Critique of NAAQS Exceedance Evaluations
Submitted to Louisiana Department of Environmental Quality
February 16, 2026

Conducted by:
Steven Klafka, P.E., BCEE
Wingra Engineering
Madison, Wisconsin

Wingra Engineering was hired by Earthjustice to assess the air modeling impact analyses submitted to the Louisiana Department of Environmental Quality (LDEQ) by nine facilities which had been issued air quality permits under the Prevention of Significant Deterioration (PSD) regulations during a time period from 2014 to 2024. To obtain their PSD permits, the facilities had conducted dispersion modeling analyses to verify compliance with air quality standards. These analyses had predicted exceedances of the national ambient air quality standards (NAAQS).

Figure 1 – Benteler Receptors & Sources Evaluating Compliance with 24-hour Average NAAQS for PM_{2.5}

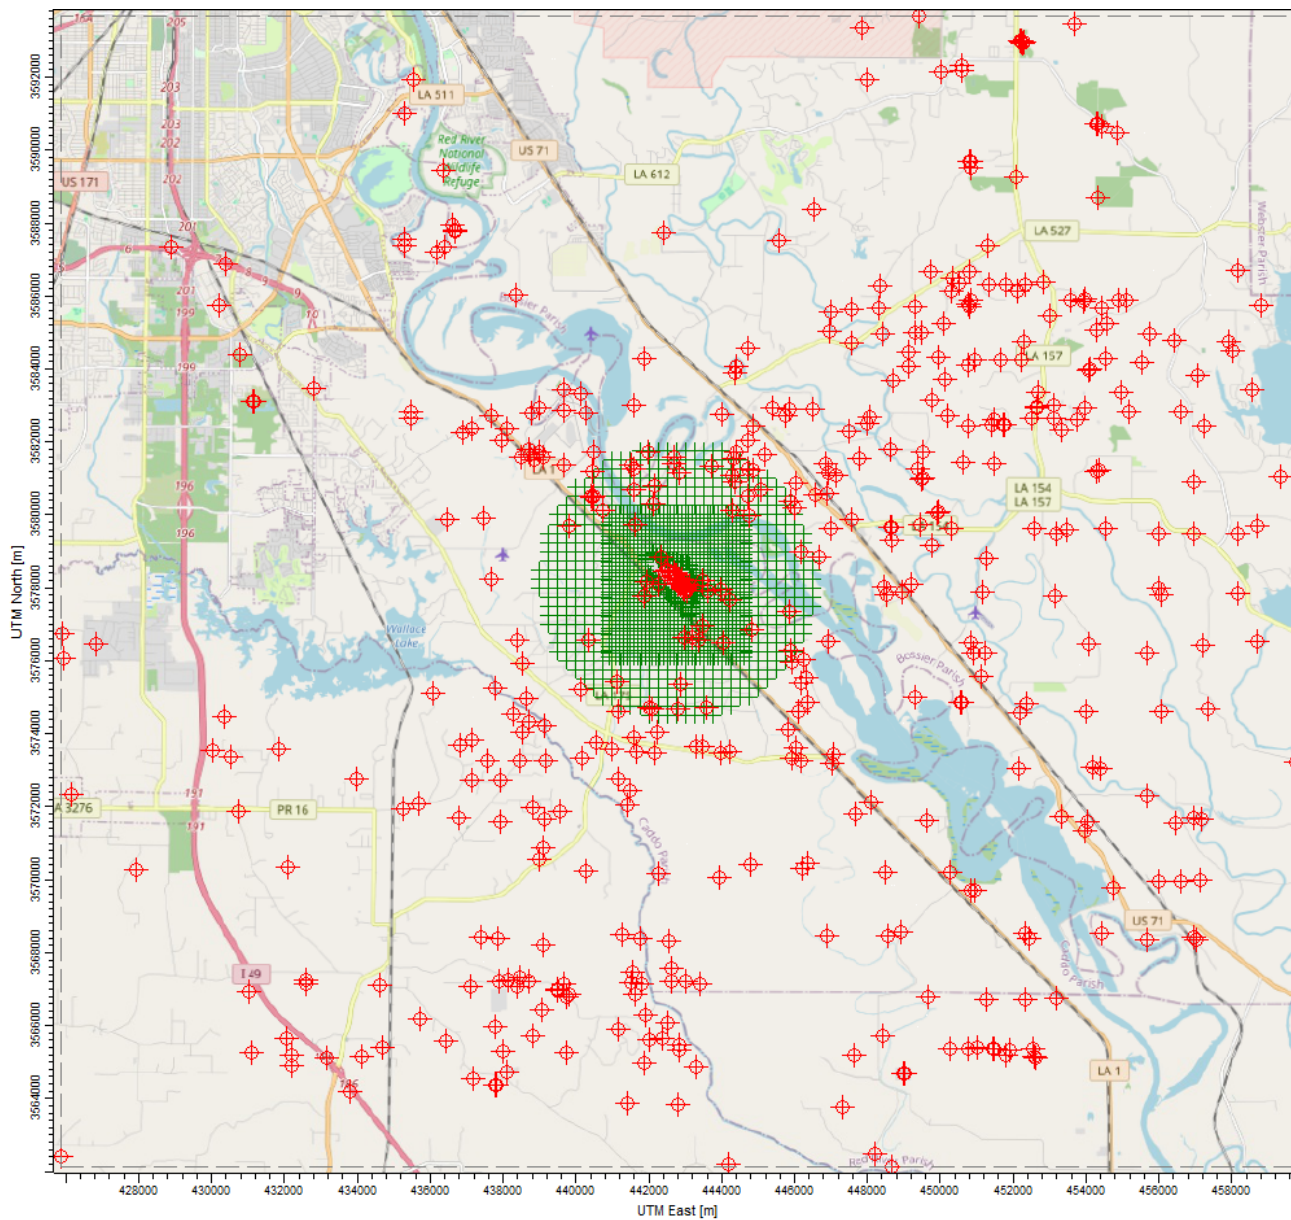
Figure 1 provided with this report displays the receptor grid and sources used to determine compliance with the 24-hour NAAQS for PM_{2.5}. The receptors are green crosses and the sources are red circles with cross hatching.

The MAXCONT file which provides the culpability of sources to the predicted maximum concentration groups them as “On-site” and “Off-site”. This analysis does not identify the specific sources responsible for the violations as requested by LDEQ.

Figure 2- Benteler Receptors & Sources Evaluating Compliance with 1-hour Average NAAQS for NO₂

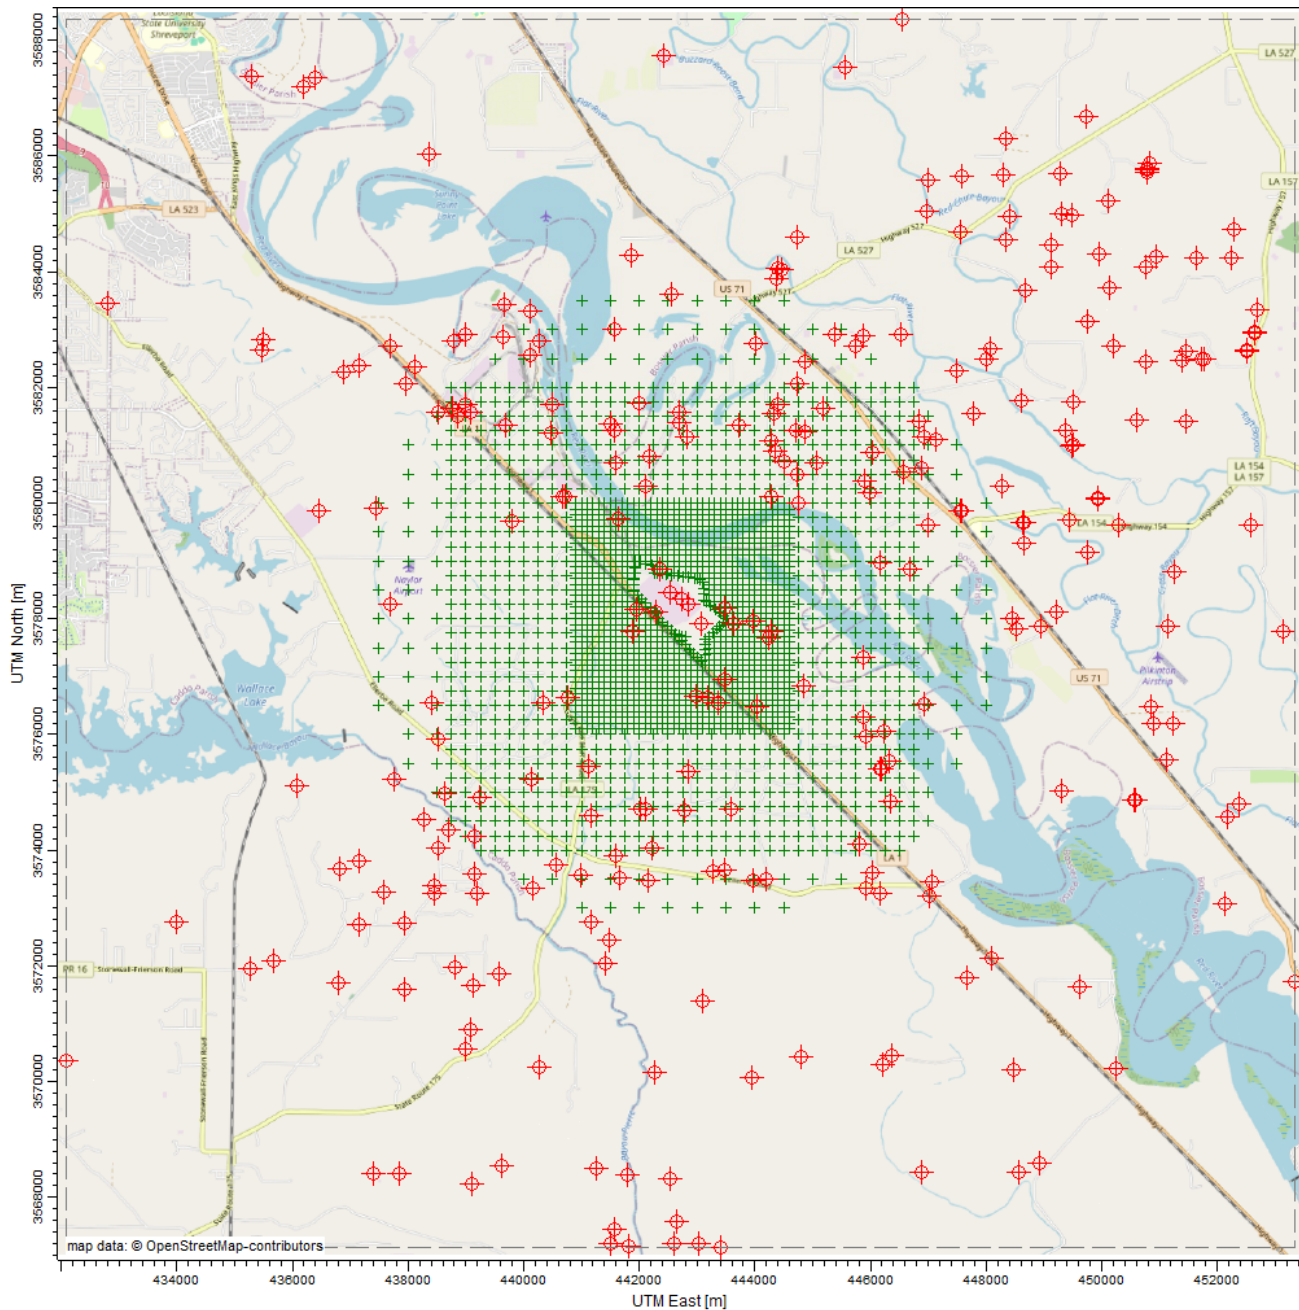
Figure 2 provided with this report displays the receptor grid and sources used to determine compliance with the 1-hour average NAAQS for NO₂. The receptors are green crosses and the sources are red circles with cross hatching.

The MAXCONT file which provides the culpability of sources to the predicted maximum concentration groups them as “On-site” and “Off-site”. This does not identify the specific sources responsible for the violations as requested by LDEQ.

Figure 4 – FG LA Receptors & Sources Evaluating Compliance with 24-hour Average NAAQS for PM_{2.5}

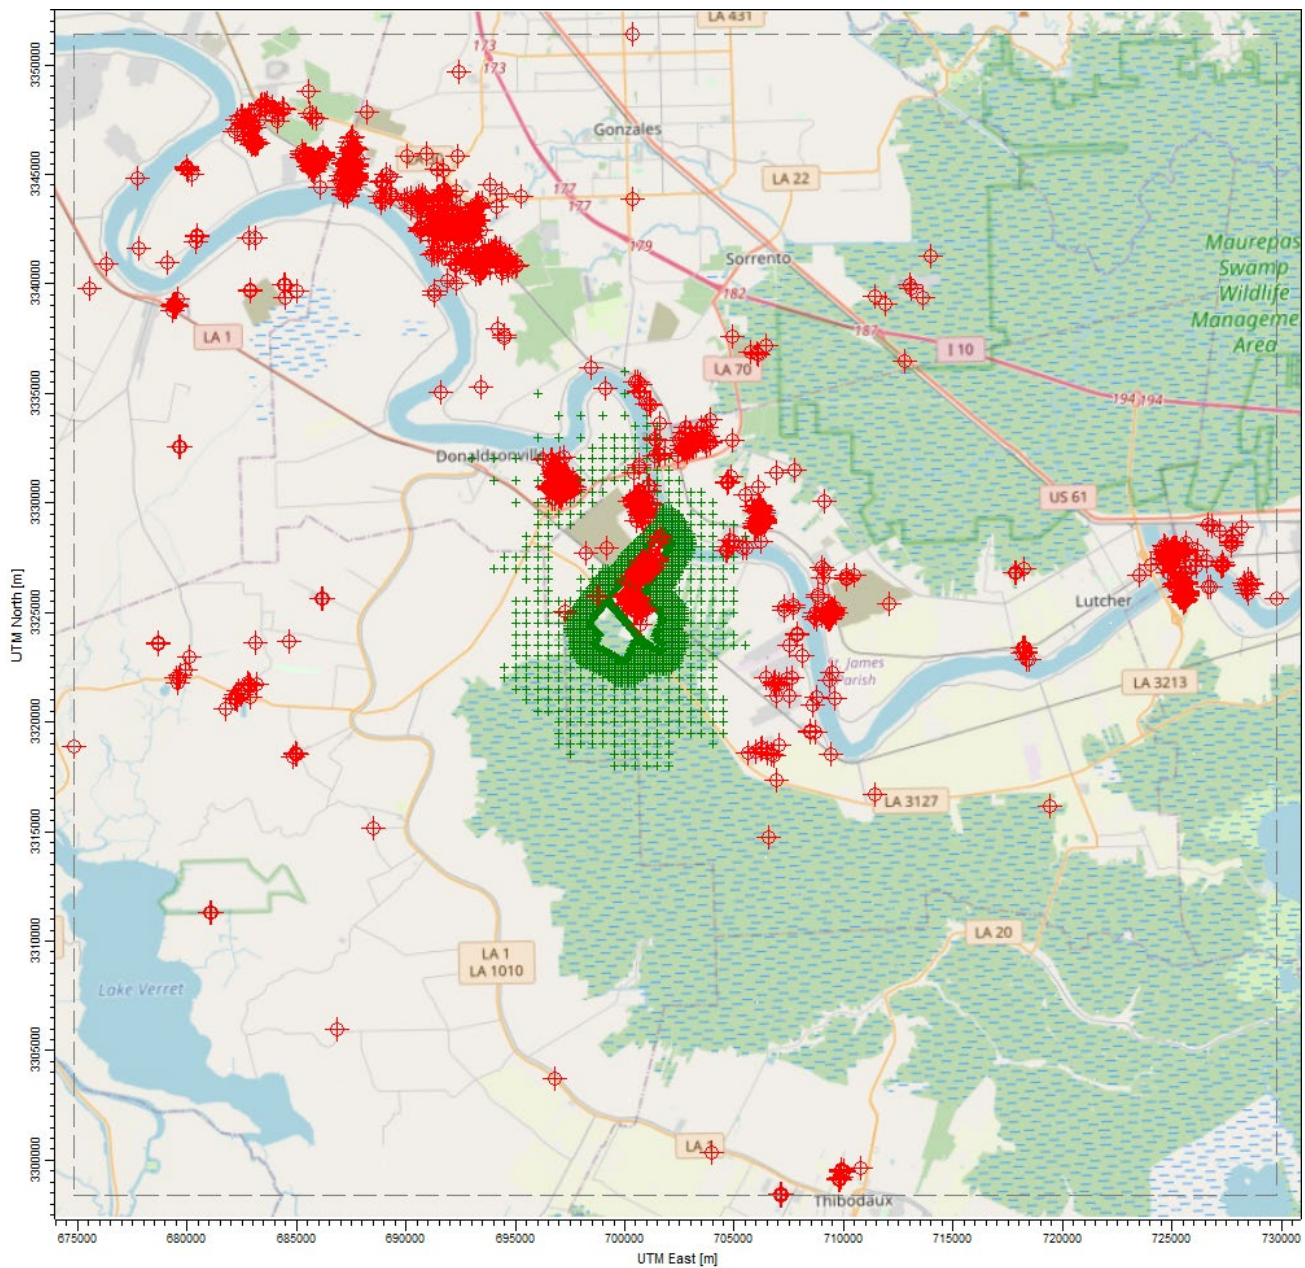
Figure 4 provided with this report displays the receptor grid and sources used to determine compliance with the 24-hour NAAQS for PM_{2.5}. The receptors are green crosses and the sources are red circles with cross hatching.

The MAXCONT file which provides the culpability of sources to the predicted maximum concentration groups them as “PROJECT1” and “PROJECT2” and “ALL1” and “ALL2”. This does not identify the specific sources responsible for the violations as requested by LDEQ.

The annual NAAQS analysis for PM_{2.5} appears to have been conducted because results below the NAAQS due to project and off-site sources is shown in Table 11-4 of the modeling report. The maximum concentration is 9.03 $\mu\text{g}/\text{m}^3$, which is below the stated NAAQS of 12 $\mu\text{g}/\text{m}^3$. However, on March 6, 2024, EPA issued a final rule tightening the PM_{2.5} NAAQS, which set the primary (health-based) annual NAAQS for PM_{2.5} at 9 micrograms per cubic meter ($\mu\text{g}/\text{m}^3$), down from the prior limit of 12 $\mu\text{g}/\text{m}^3$. The modeling results exceed the current NAAQS so the analysis should be repeated to verify compliance with the current NAAQS.

Figure 6 – Marathon Receptors & Sources Evaluating the Annual Average NAAQS for PM_{2.5}

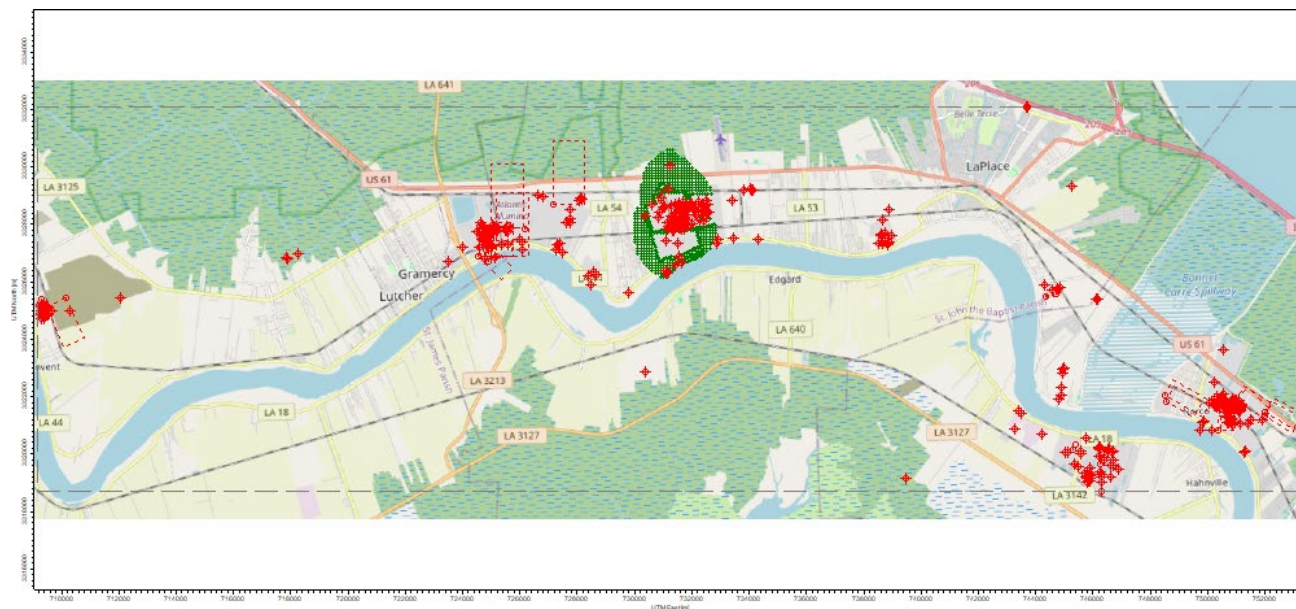
Figure 6 provided with this report displays the receptor grid and sources used to determine compliance with the annual NAAQS for PM_{2.5}. The receptors are green crosses and the sources are red circles with cross hatching.

The total predicted concentration was 2.48 µg/m³. Since LDEQ didn't flag this as an exceedance requiring further evaluation, it is assumed this demonstrated compliance with the annual NAAQS for PM_{2.5}, which was likely 12 µg/m³ when the PSD permit was issued. However, there are shortcomings of this modeling analysis for PM_{2.5} which ignores potential NAAQS violations. This analysis used only 735 receptors extending to approximately 2 km from the center of the site. There were 895 total sources with the off-site sources were no further than 22 km from the center of the site. The number of receptors and their short distance from the facility suggest they represent only receptors where the project exceeded the SIL. Many of the off-site sources had no receptors located near them so possible exceedances near the off-site sources would not be predicted.

To identify all possible exceedances within the 50 km acceptable modeling domain for AERMOD, the modeling for NAAQS compliance needs to be repeated using a receptor grid that extends out to 50 km. The additional off-site sources located throughout the 50 km acceptable modeling domain for AERMOD need to be included to identify potential NAAQS exceedances throughout the modeling domain. As noted under Section 2.0 of this report, even LDEQ modeling guidance requires consideration of all off-site sources located within 50 km beyond the Significant Impact Area.

Figure 7 – Marathon Receptors & Sources Evaluating Compliance with 1-hour Average NAAQS for NO₂

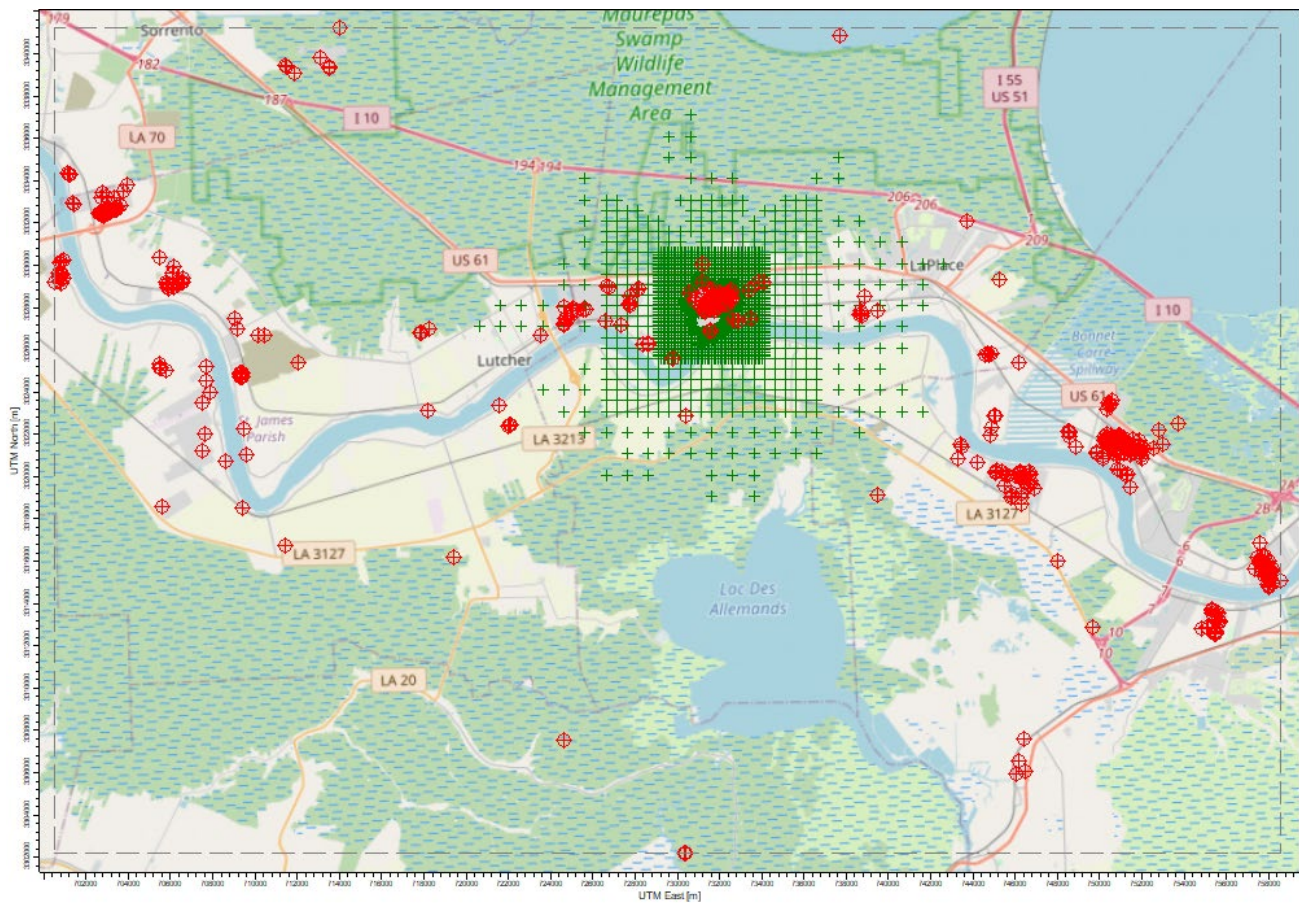
Figure 7 provided with this report displays the receptor grid and sources used to determine compliance with the 1-hour average NAAQS for NO₂. The receptors are green crosses and the sources are red circles with cross hatching.

The number of receptors and their short distance from the facility suggest they represent only receptors where the project exceeded the SIL. Many of the off-site sources had no receptors located near them, so possible exceedances near the off-site sources would not be predicted.

To identify all possible exceedances within the 50 km acceptable modeling domain for AERMOD, the modeling for NAAQS compliance needs to be repeated using a receptor grid that extends out to 50 km. The additional off-site sources located throughout the 50 km acceptable modeling domain for AERMOD need to be included.

Figure 8 – Nucor Receptors and Sources Evaluating Compliance with 1-hour Average NAAQS for NO₂

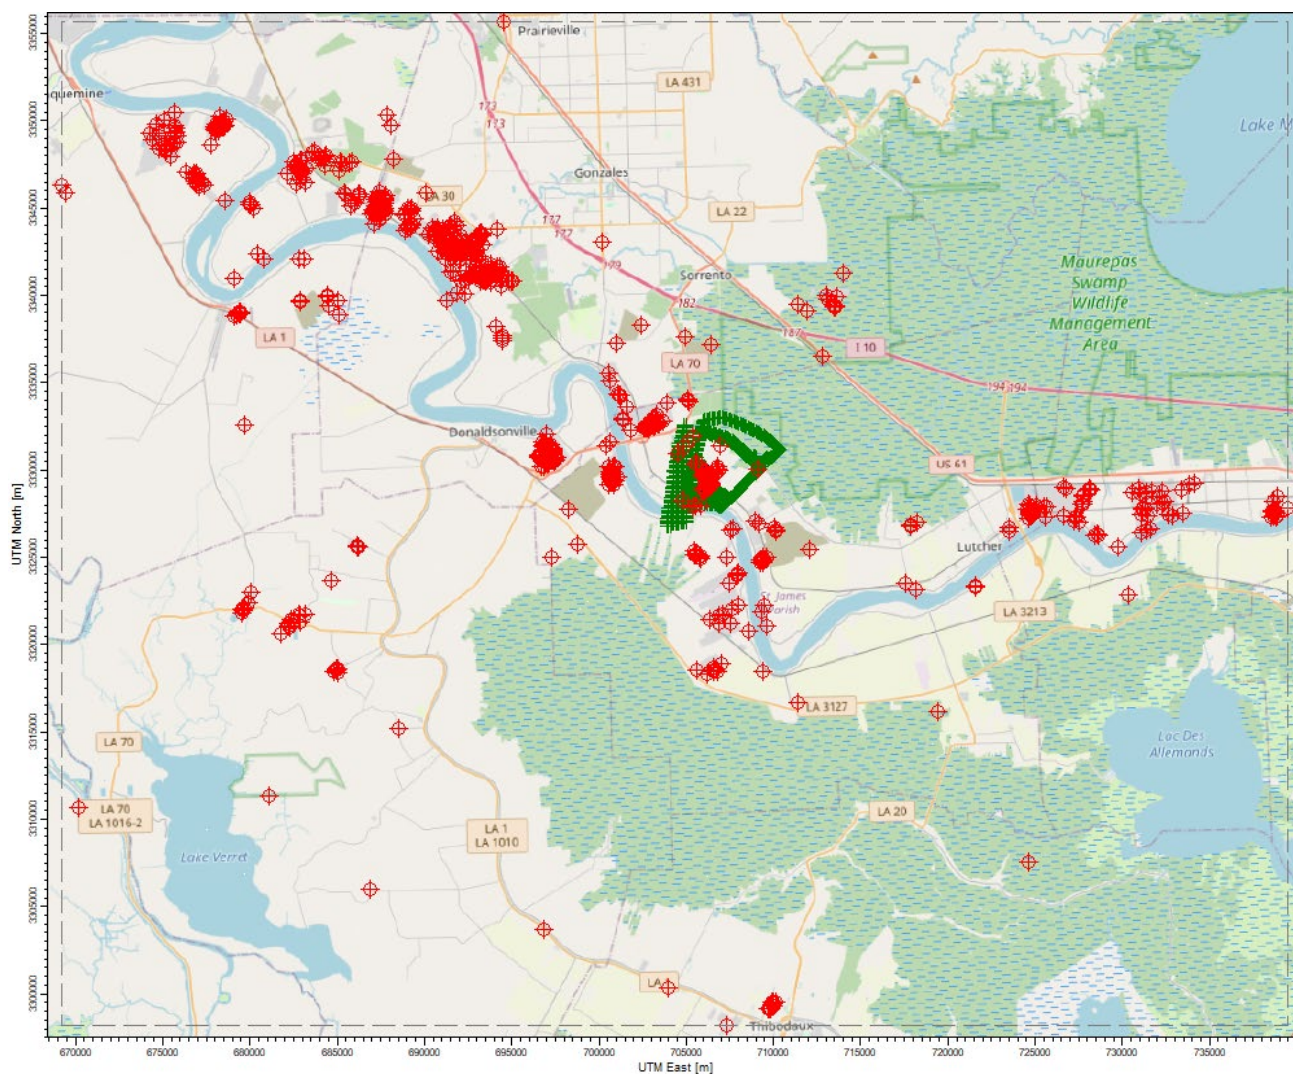
Figure 8 provided with this report displays the receptor grid and sources used to determine compliance with the 1-hour average NAAQS for NO₂. The receptors are green crosses and the sources are red circles with cross hatching.

Grouping off-site sources into the CONT_ALL does not provide the information required by LDEQ to identify the culpability of each source responsible for exceedances of the NAAQS.
